NL-05-0990

Vogtle Electric Generating Plant
Response to NRC Request for Additional Information Regarding
Relaxation From First Revised NRC Order EA-03-009

**SNC Response to NRC RAI Regarding
Vogtle Electric Generating Plant Units 1 and 2
Relaxation From First Revised NRC Order EA-03-009**

Figure 1

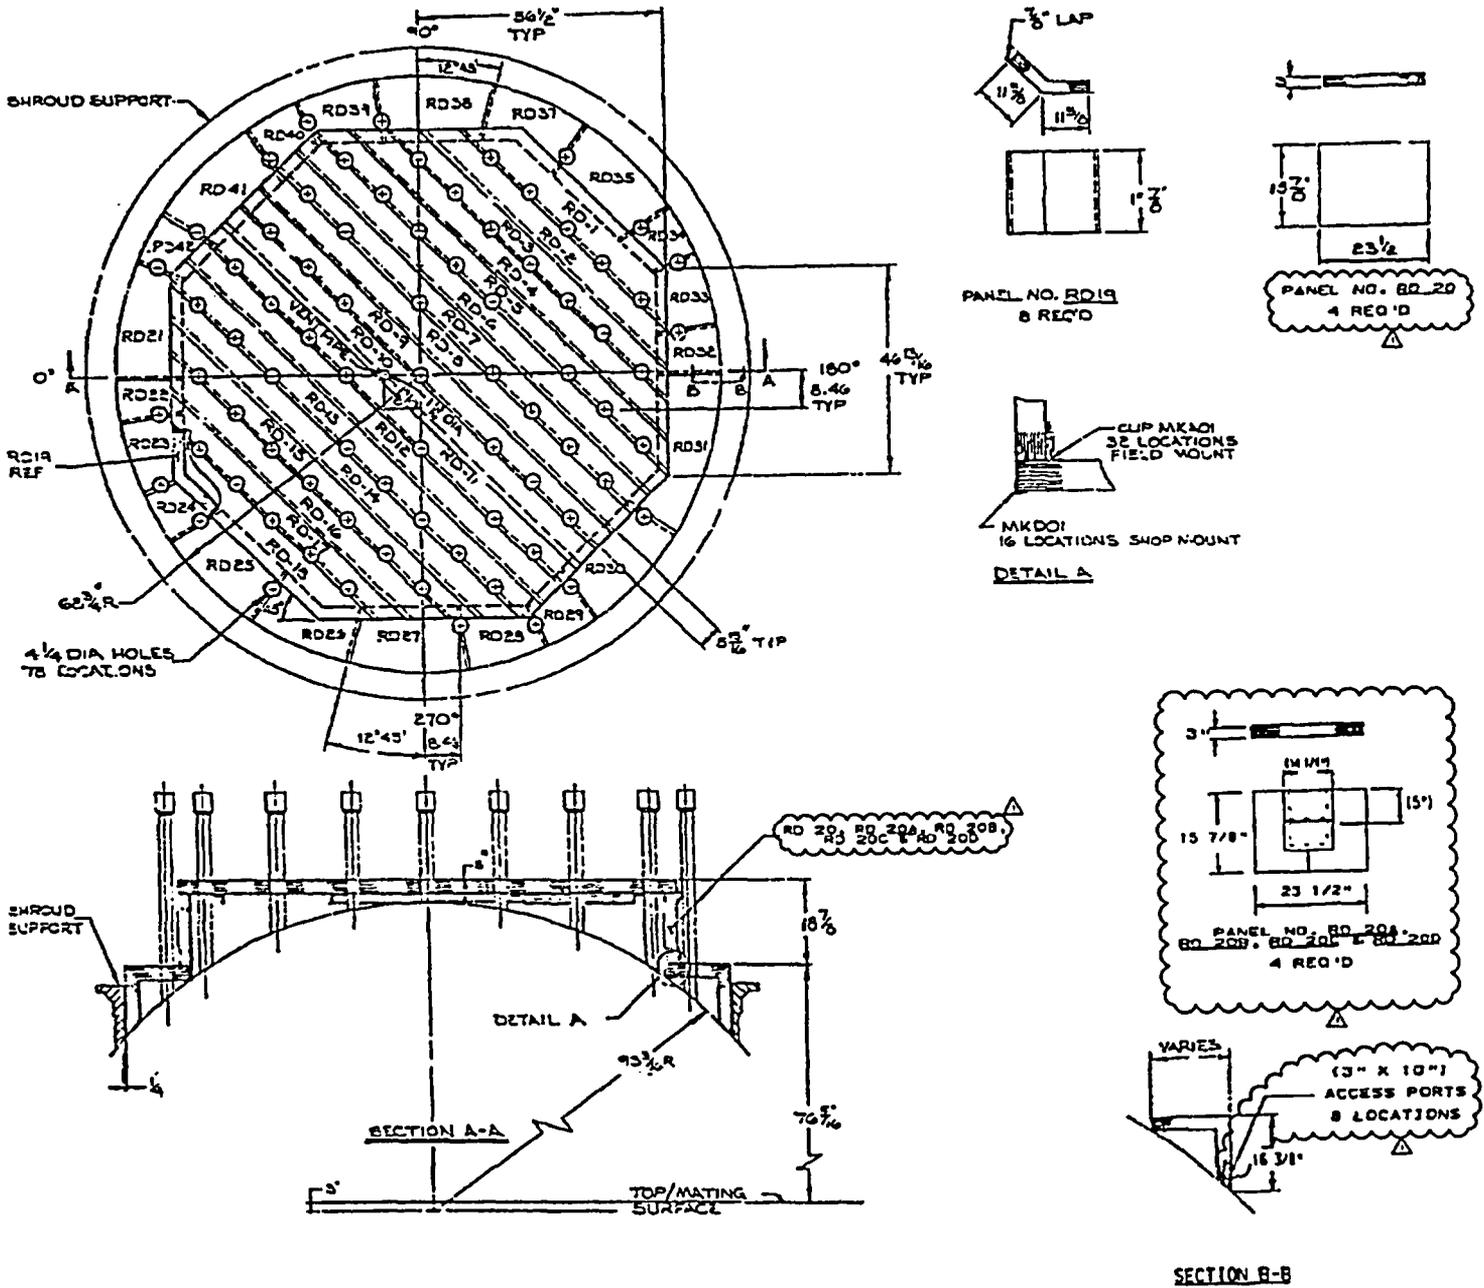
What are the physical limitations imposed on the bare metal visual inspection by the reflective metal insulation? Provide details on where limitations to the inspection due to insulation obstructions and camera limitations.

As stated in SNC's response to NRC question 1, the configuration of the RPV upper head and the RPV upper head insulation is the same for VEGP Units 1 and 2. The total surface in the area encompassed by D1 shown on figure 1 (enclosure page 3 of 5) for the RPV upper head was calculated using the first formula on figure 1 and determined to be 19,338 square inches. Figure 1 is found in ASME Section XI Code Case N-729, "Alternative Examination Requirements for PWR Reactor Vessel Upper Heads With Nozzles Having Pressure-Retaining Partial-Penetration Welds." The area shown as detail "A" on figure 2 (enclosure page 4 of 5) restricts the bare metal visual (BMV) examination within D1 except at the ends where the crawler could see and sometimes could get through for a short distance. With each of these eight panels typically 46.8125 inches in length, approximately 80% or 37.45 inches of the length of each panel is obstructed as shown on figure 3
